HISTORIC AND DESIGN REVIEW COMMISSION

August 21, 2019

HDRC CASE NO: 2019-449
ADDRESS: 519 NOLAN
LEGAL DESCRIPTION: NCB 546 BLK 19 LOT 15 & E 5.58 FT OF 14
ZONING: R-6, H
CITY COUNCIL DIST.: 2
DISTRICT: Dignowity Hill Historic District
APPLICANT: Aaron Peterson/PETERSON AARON
OWNER: Aaron Peterson/PETERSON AARON
TYPE OF WORK: New construction
APPLICATION RECEIVED: August 01, 2019
60-DAY REVIEW: September 30, 2019
CASE MANAGER: Edward Hall

REQUEST:

Proposed location of garage (in yellow)

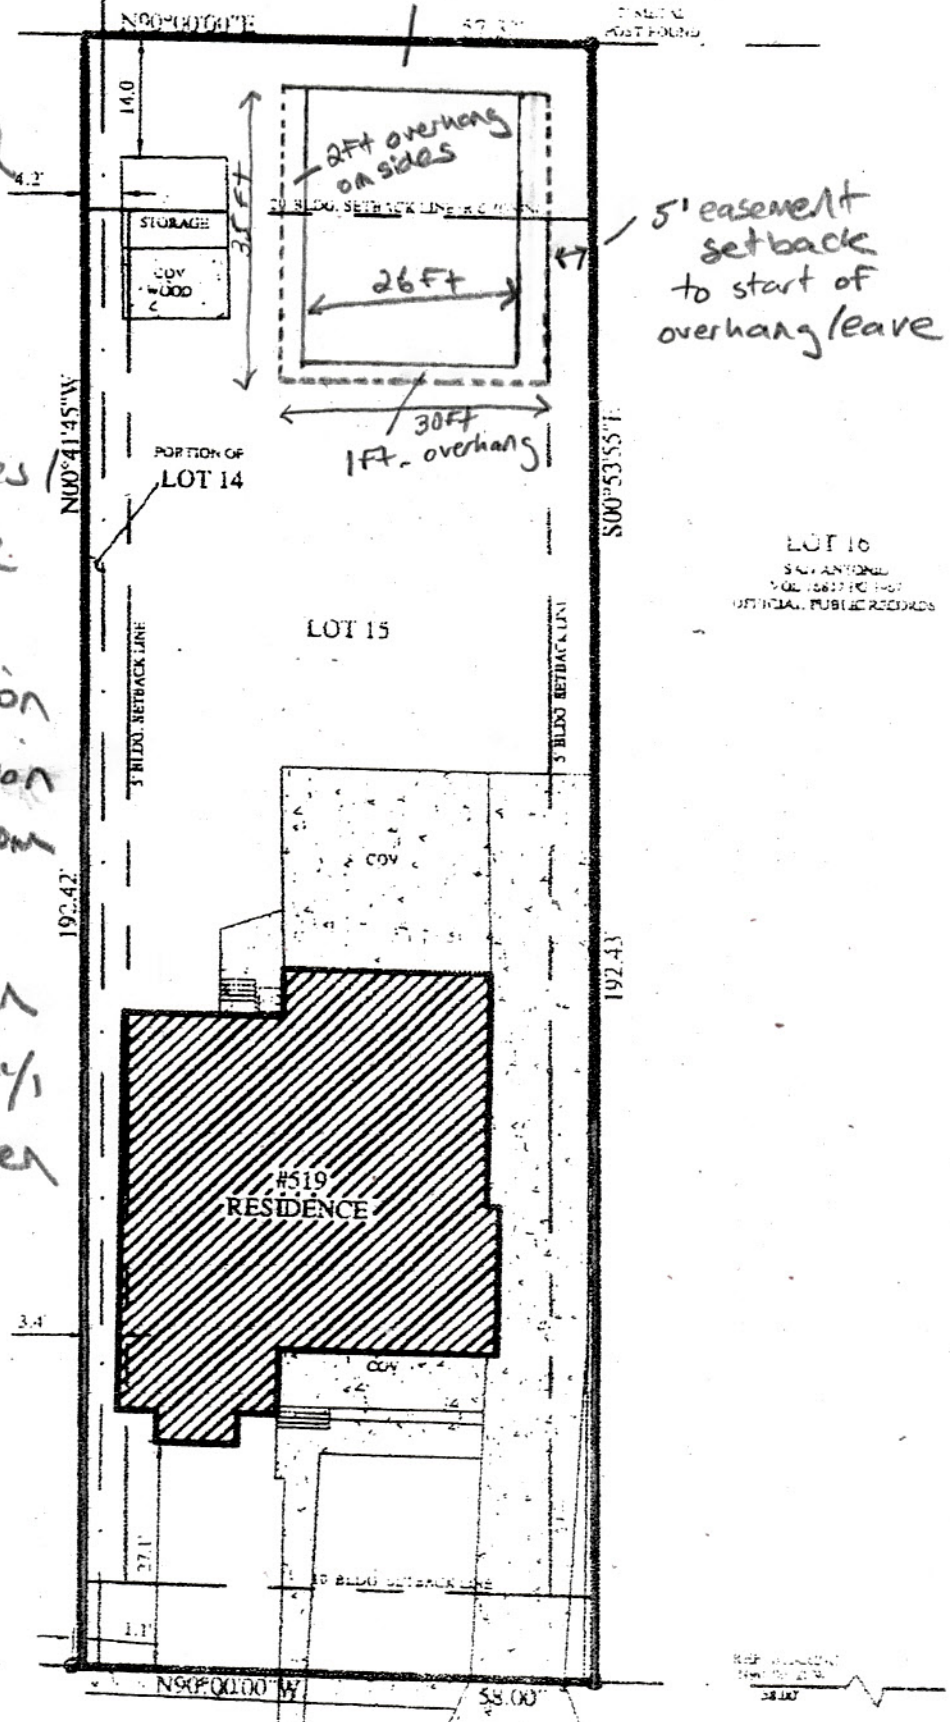
should be followed. The applicant has proposed to locate the accessory structure at the rear of the property, where accessory structures are historically located within the district. Generally the proposed setbacks and orientation are appropriate and consistent with the Guidelines.

- d. **FOOTPRINT** – As noted in finding a, the applicant has proposed a footprint to feature approximately 900 square feet. The Guidelines for New Construction 5.a.ii. notes that new accessory structures should be no larger in plan than 40 percent of the primary historic structure’s footprint. The existing historic structure features a footprint of approximately 1,660 square feet. The total lot size is approximately 11,200 square feet. The proposed footprint is not consistent with the Guidelines as it is more than 40 percent of the primary historic structure’s footprint.

North
Elevation

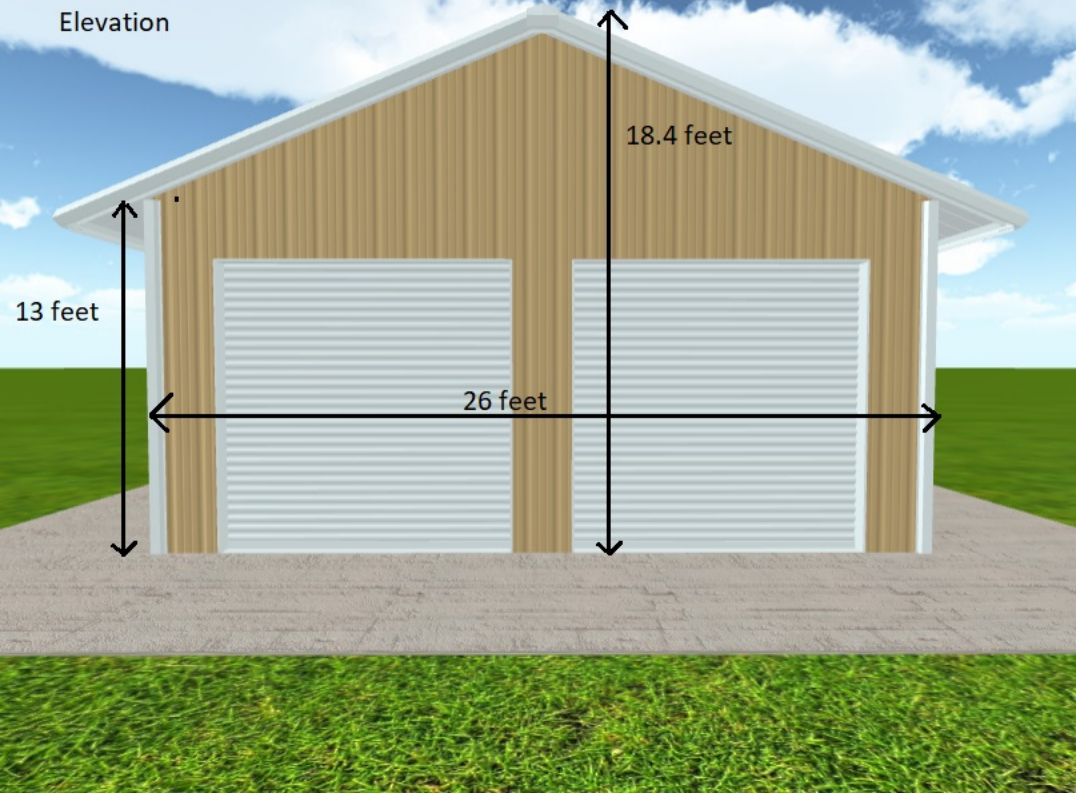
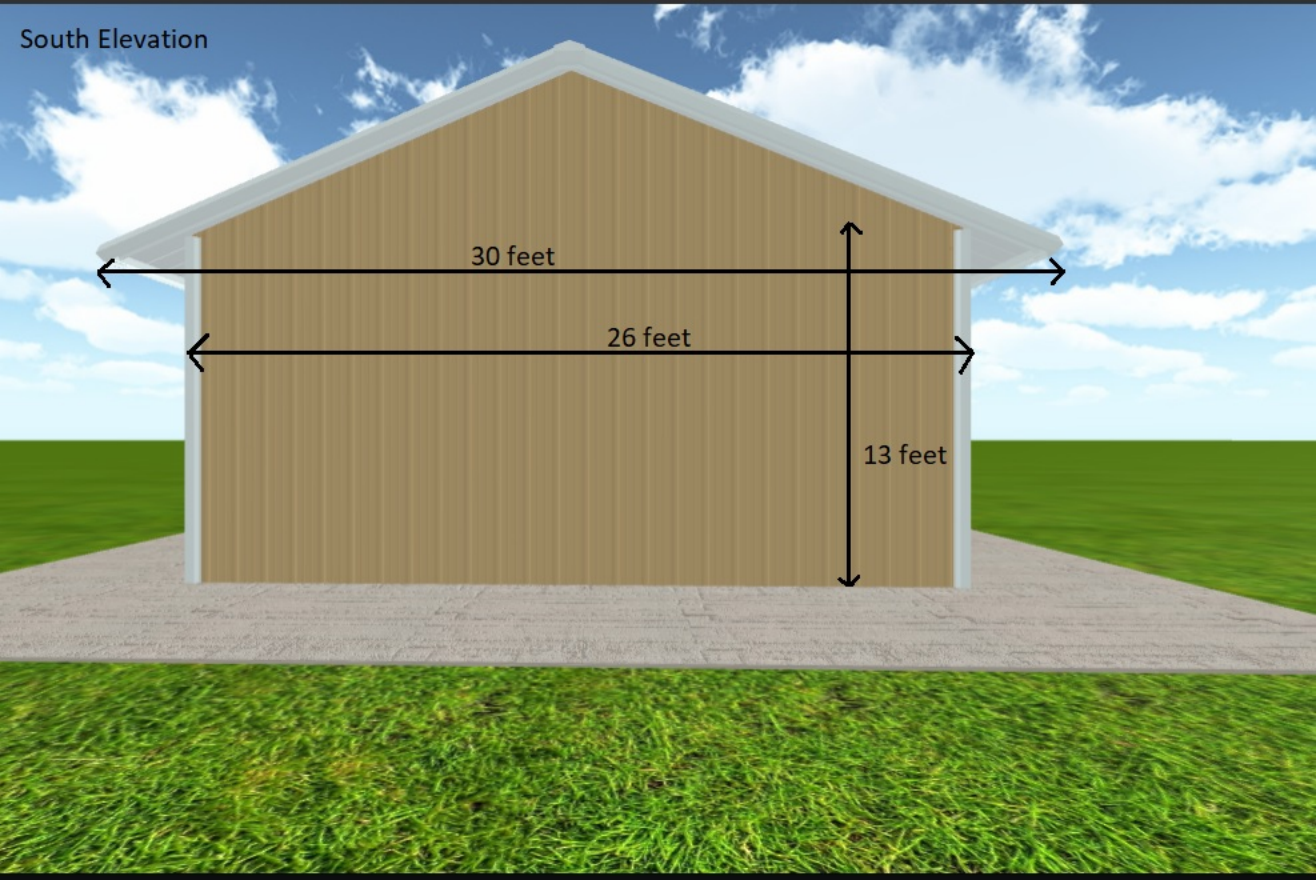
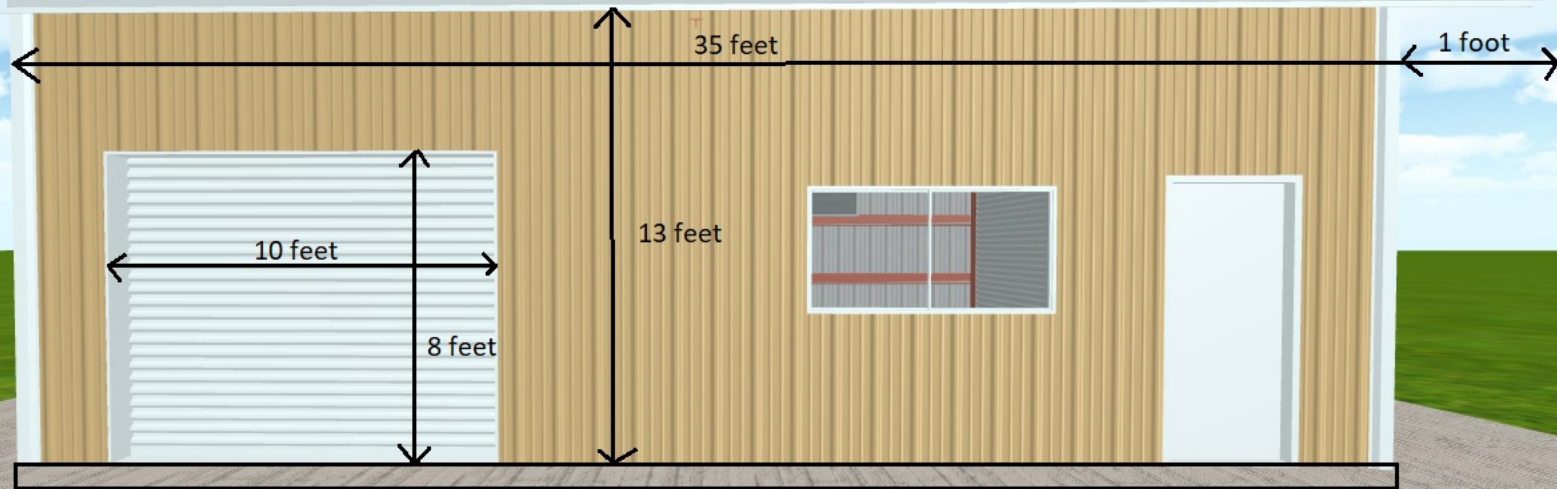
- c. **MASSING** – The Guidelines for New Construction 5.A.i. notes that new garages and outbuildings should be visually subordinate to the principal historic structure in terms of their height, massing and form. The applicant has proposed an overall height of approximately eighteen (18) feet in height. Generally, the proposed height is consistent with the Guidelines.

- e. **CHARACTER** – The Guidelines for New Construction 5.A.iii. notes that new garages and outbuildings should relate to the period of construction of the primary historic structure on the lot through the use of complementary materials and simplified architectural details. The applicant has proposed for the structure to feature metal panel walls. Staff finds the proposed materials to be inconsistent with the Guidelines.

- f. **MATERIALS** – As noted in finding e, the applicant has proposed for the structure to primary consist of metal panels. This is inconsistent with the Guidelines. Staff finds that accessory structures located within historic district should feature materials that are consistent with those found on historic accessory structures; typically, wood framing, wood siding and a standing seam metal roof. Staff finds that composite siding would be an appropriate alternative for wood siding.

- h. **GARAGE DOORS** – The applicant has proposed metal, overhead rolling garage doors. Generally, staff finds that wood doors would be most appropriate for the Dignowity Hill Historic District.

Staff does not recommend approval based on findings a through h. Staff recommends that the applicant proposed materials that are comparable to those historically used for accessory structures within the Dignowity Hill Historic District.
